CITY OF ALBUQUERQUE

**RE: San Roque / La Serena
441 & 457 Coors Blvd NW
Grading & Drainage Plan and Drainage Report
Engineer's Stamp Date: 06/10/21
Hydrology File: J10D049**

Based upon the information provided in your submittal received 06/10/2021, the Grading & Drainage Plan and Drainage Report **are not** approved for Building Permit and action by the DRB on Preliminary Plat or Site Plan for Building Permit. The following comments need to be addressed for approval of the above referenced project:

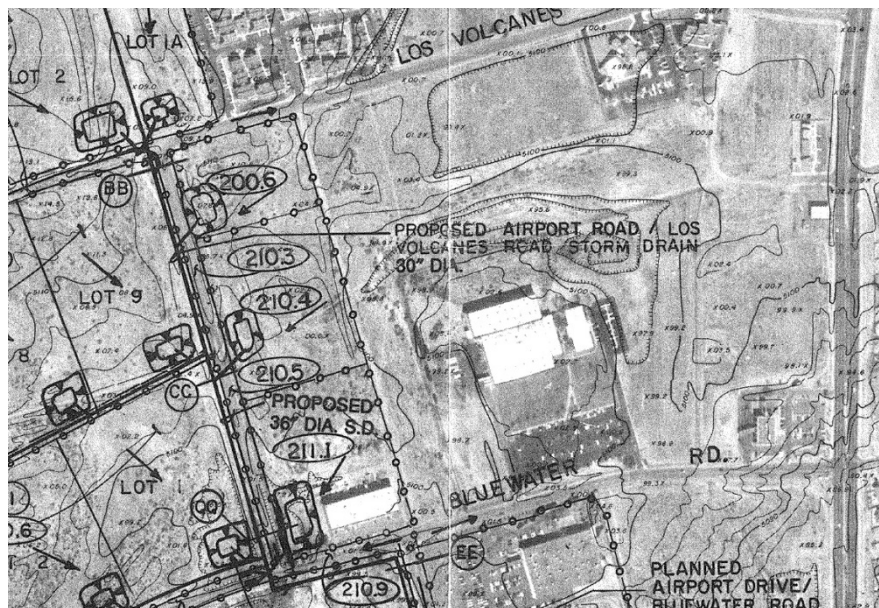
1. Under Existing Conditions, the report states, " This site lies within the Atrisco Business Park Master Plan.....". This is false, below is the basin map from the report and this site is not in the report area. However as noted, the existing 60-in public storm pipe stops on the project's site without any City's plans to extend the storm system. Therefore this site will be able to freely discharge into this existing 60-in with no problem since there is plenty of capacity. Please discharge into a revised stormwater quality pond prior to the connection to this existing pipe. (see below for the as-builts of that existing 60-in pipe)

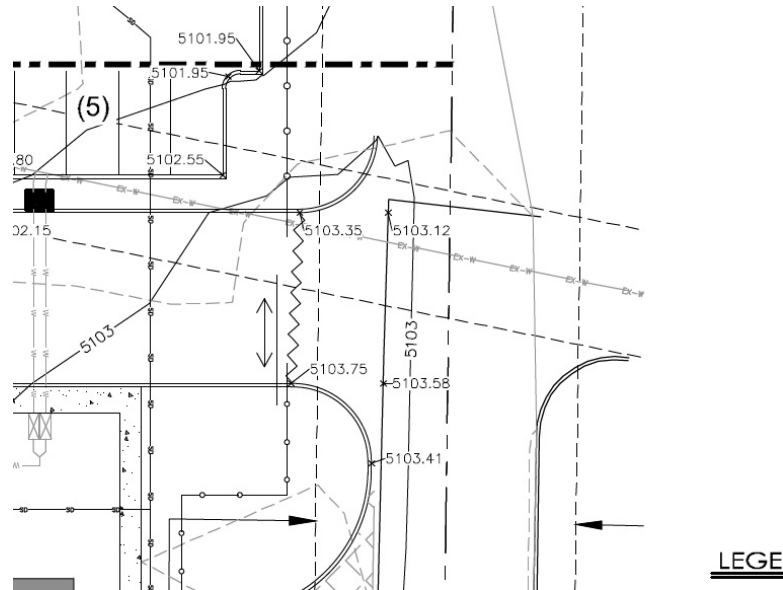
6. Sheet 2.1. I noticed that the existing asphalt is cracked and not completely straight as shown the photo below. Please show where there will be a saw cut on the existing pavement. Also please indicate the existing top of pavement along the saw cut. Since this work is also on the adjacent property, please provide a notarized letter stating that this work can be done by that property owner. Also please provided the top of curb information at the end of the radius on this drive entrance.

Grading &
Drainage Plan

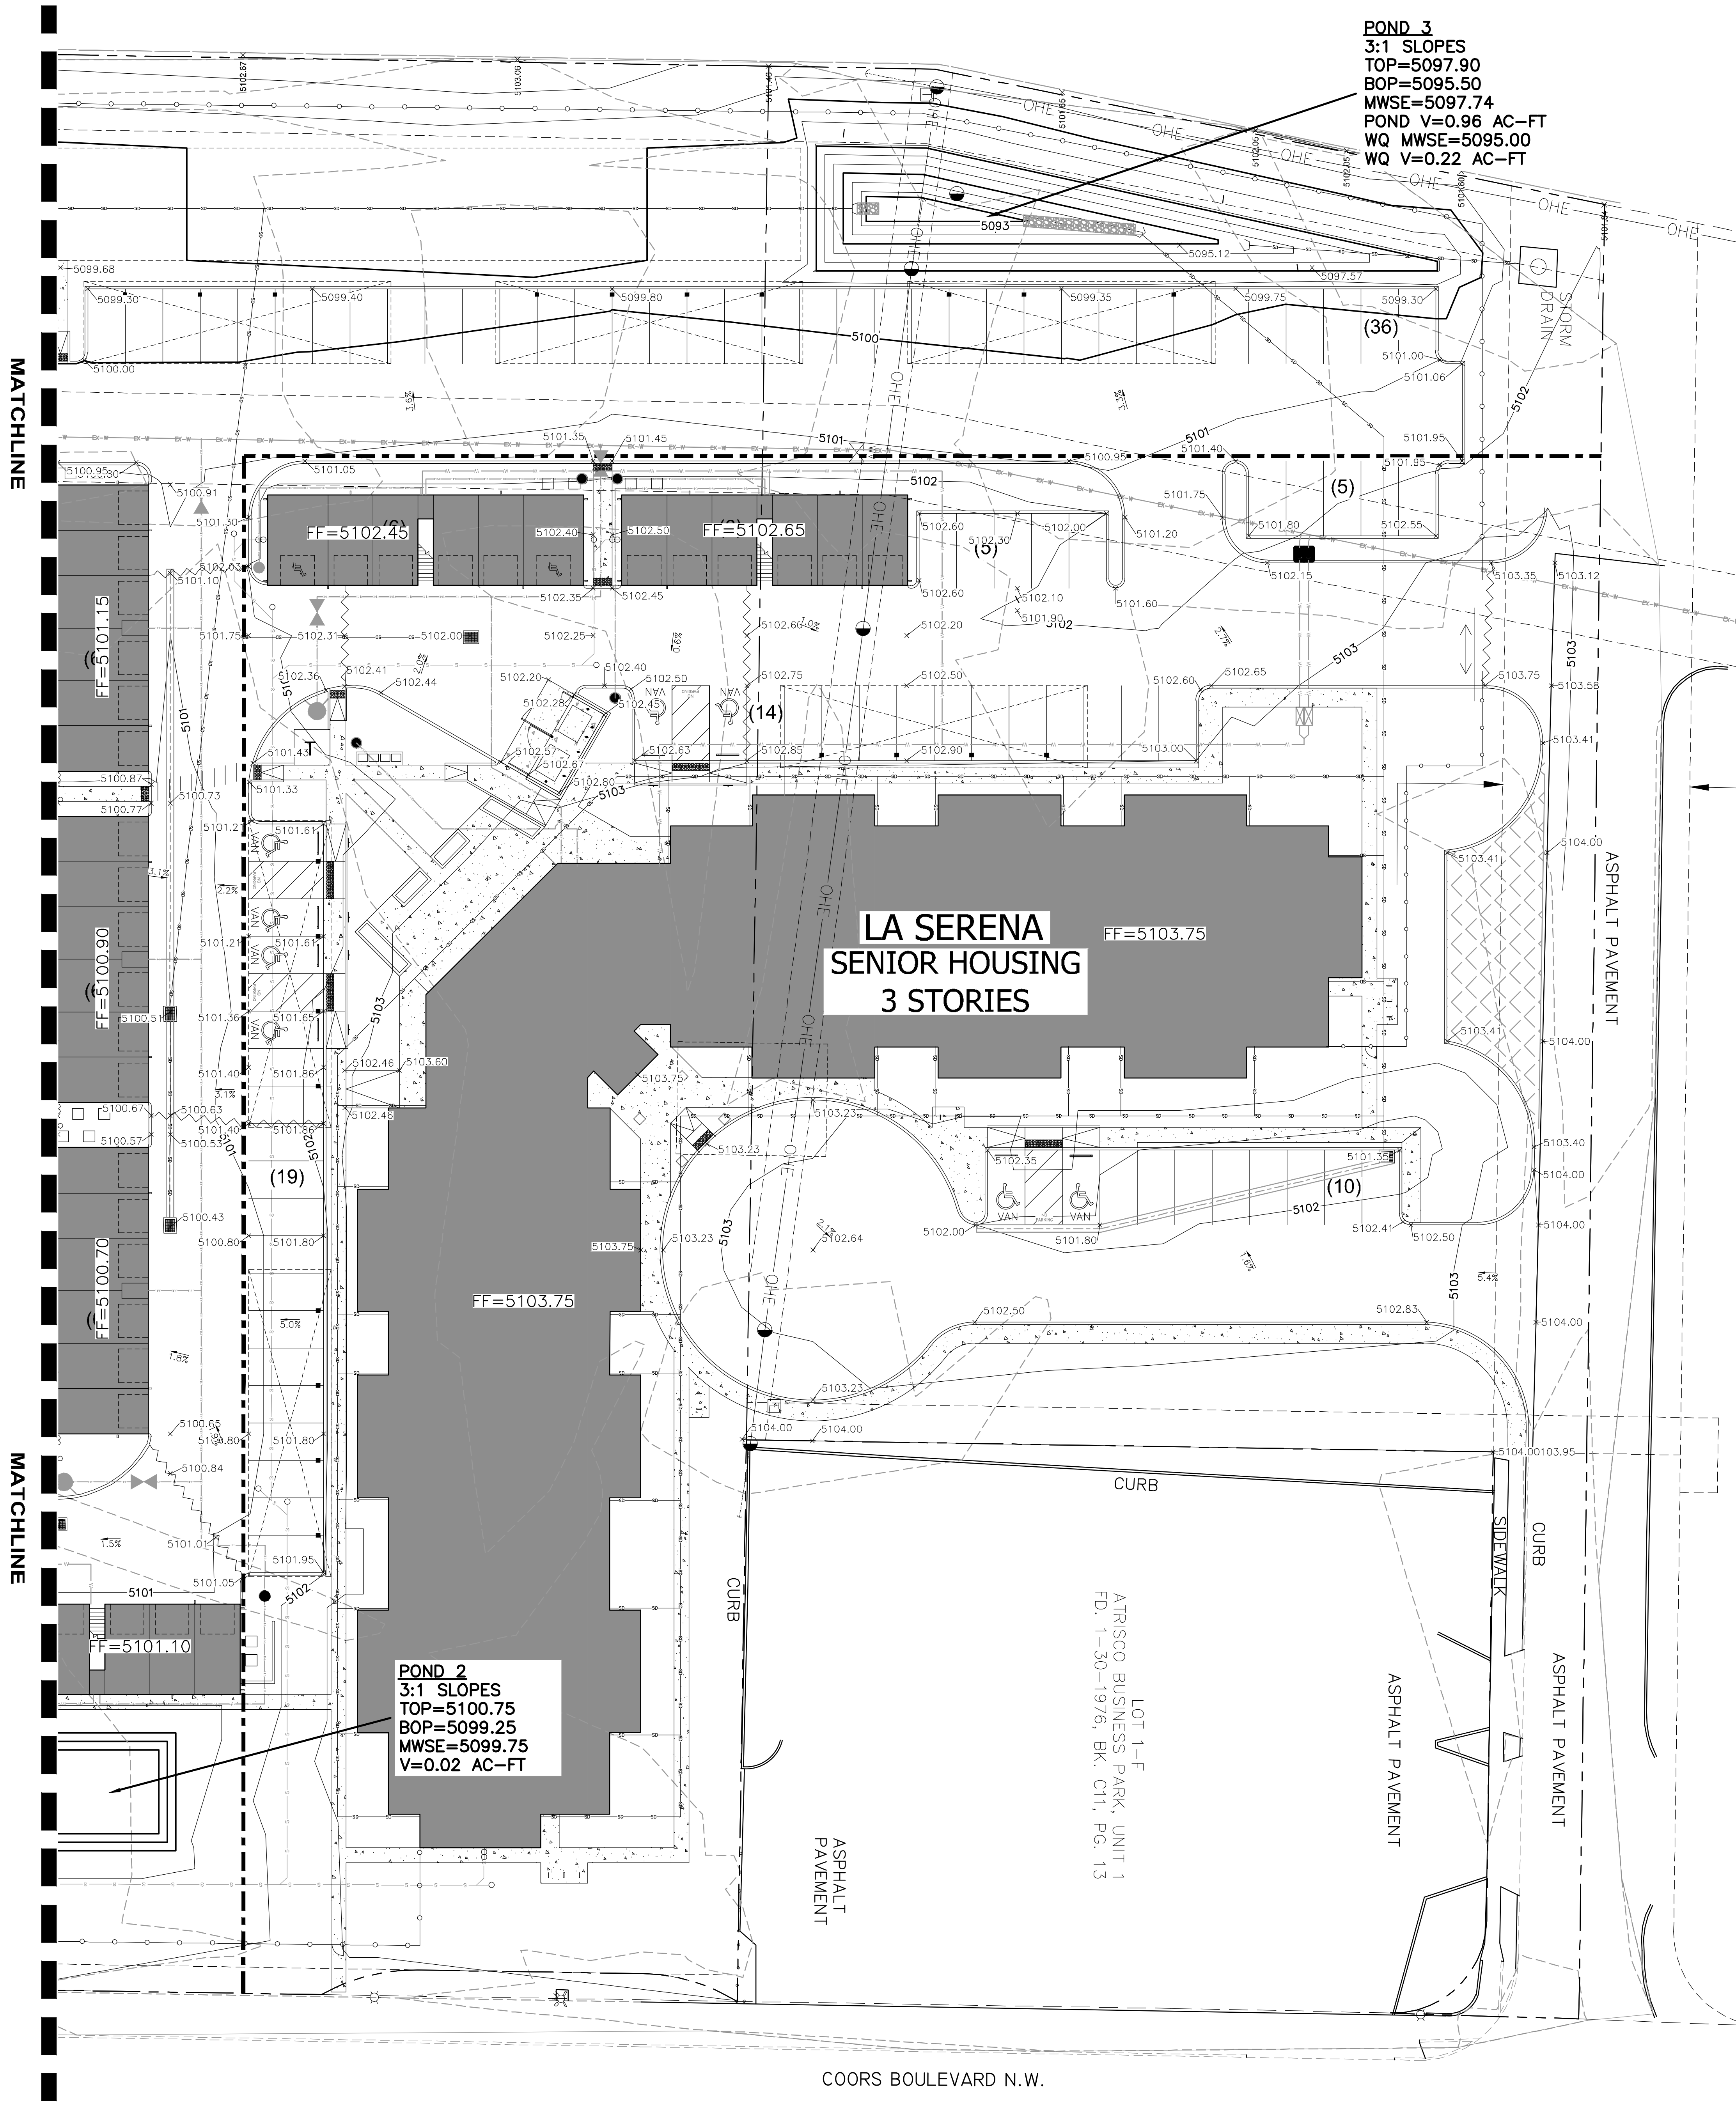
4. Sheet 2.1 & 2.2. Please add what kind of spot elevations these are. (i.e. top of curb, flow line, or top of pavement).
5. Sheet 2.1 & 2.2. Please add the top of grate elevation where there is a grate. It is hard to keep turning to the storm pipe sheet for that information.

Grading & Drainage Plan
c2.2

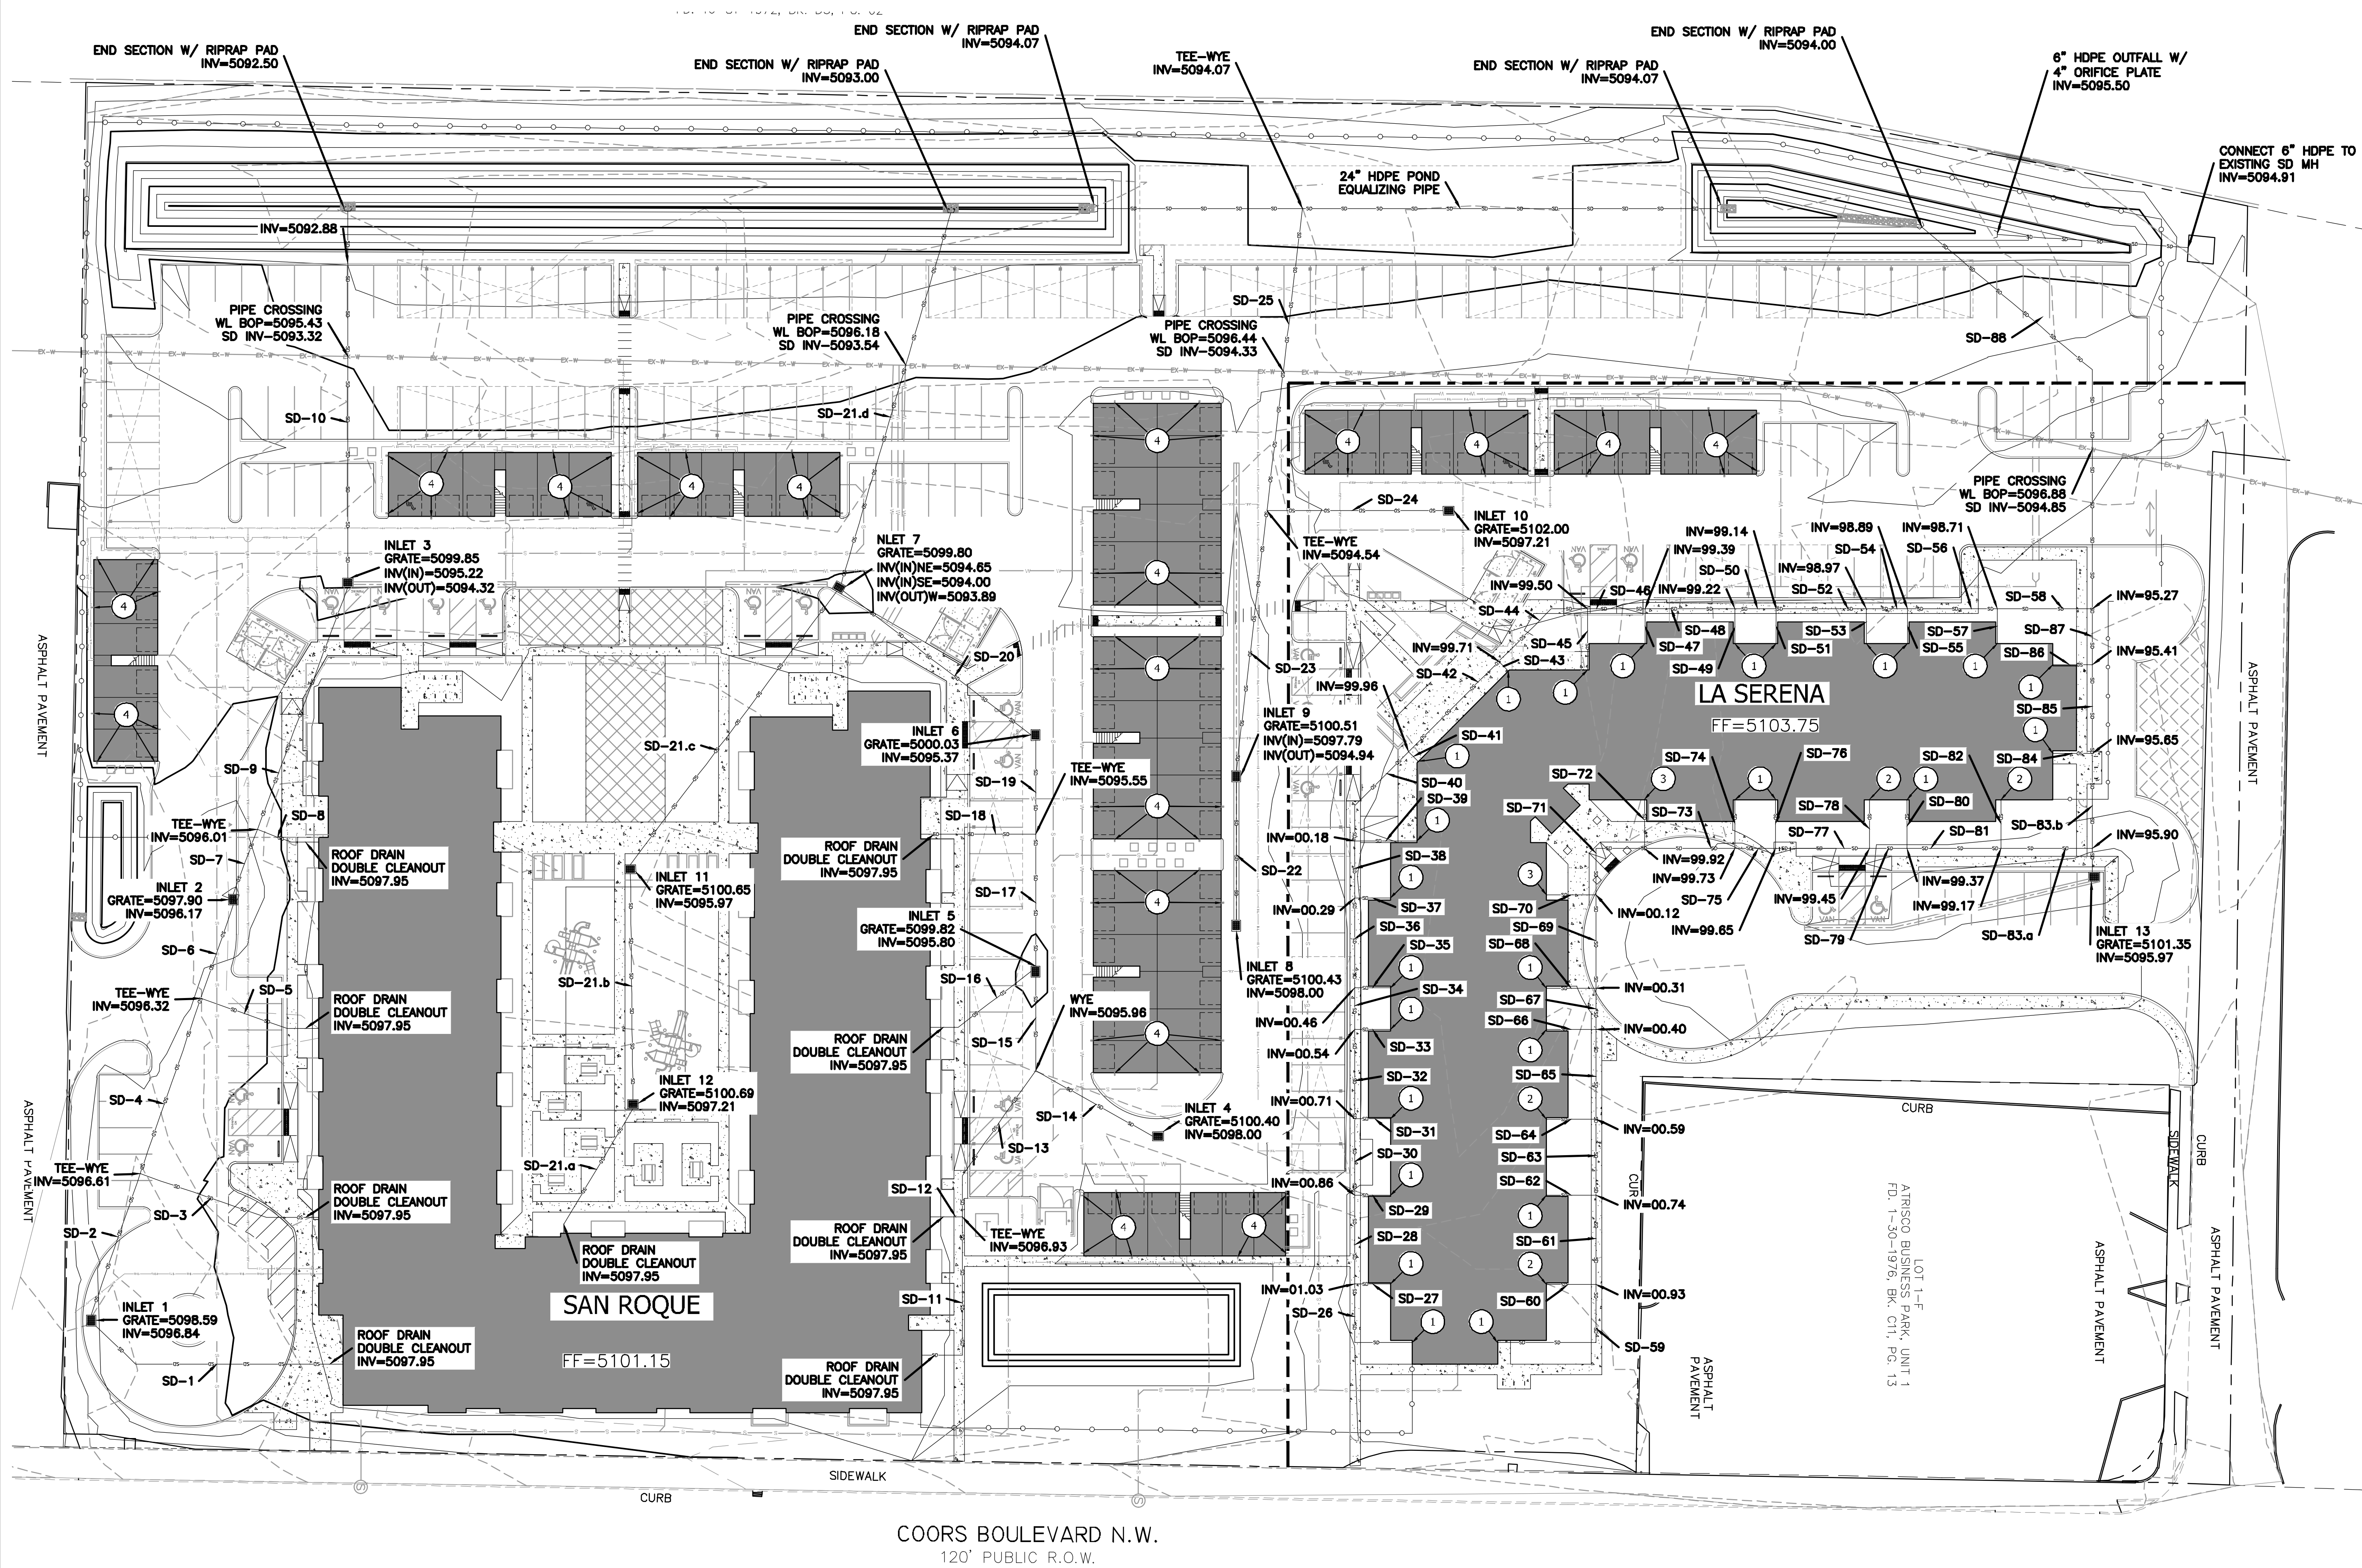
7. Sheet 2.2. I believe that the existing edge of the asphalt is partially shown but please show the entire edge of it as shown in the photo along with the top of curb for the other side of the adjacent entrance. Is there going to be some additional asphalt from the end of the proposed curb radius to the existing curb on the other side of the access drive? If so, then please provide the spot elevations needed to build this.
